RE: 2150 Charlton Road – Major Site Plan Review and Conditional Use Permit

## Memorandum

Re: Major Site and Building Plan Review, Submittal 03/18/19  
2150 Charlton Rd  
City of Sunfish Lake, MN  
WSB Project No. 013723-000

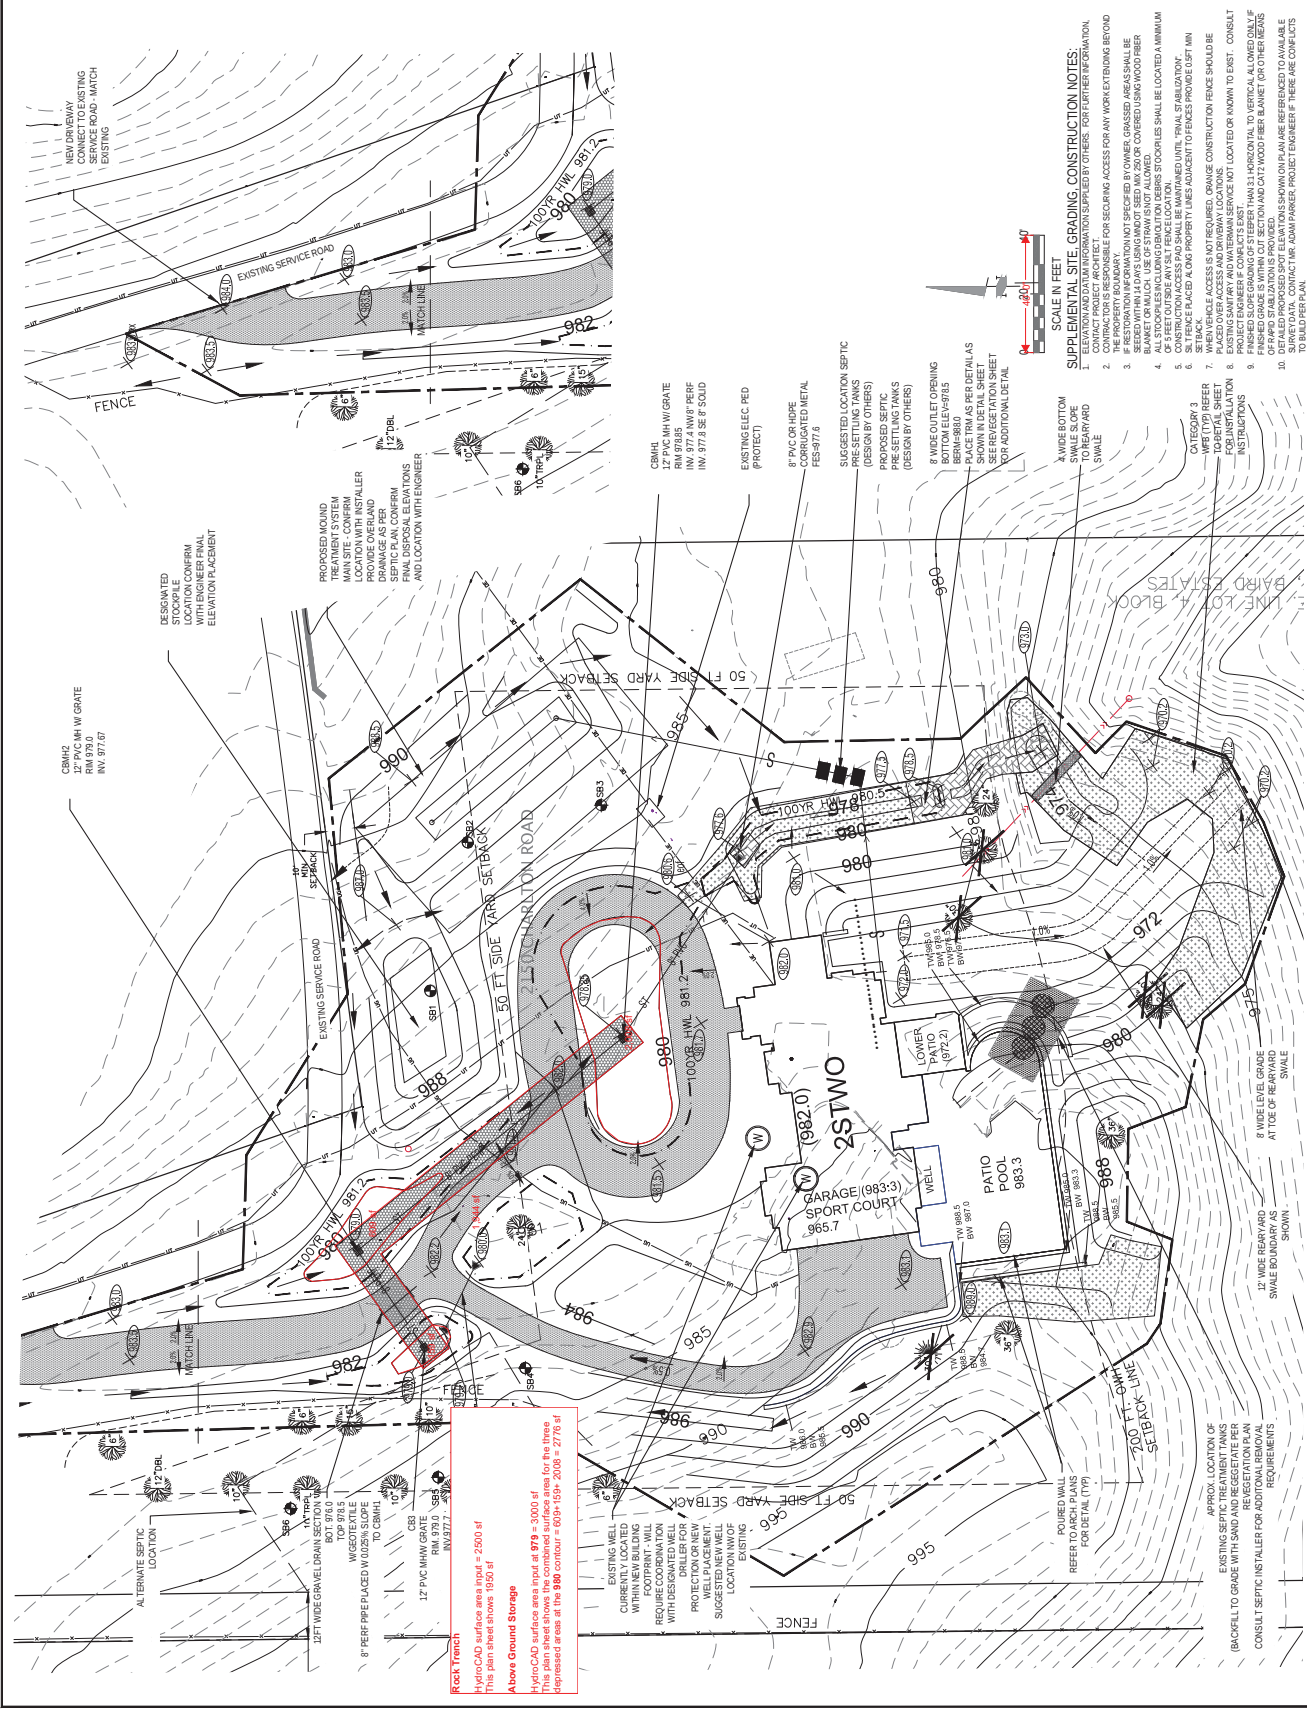
3. Surface area inputs for the Pond RC node in the HydroCAD model are not representative of what is shown in the plan (see attached). Applicant should update the HydroCAD model to be consistent with the grading shown in the plan.
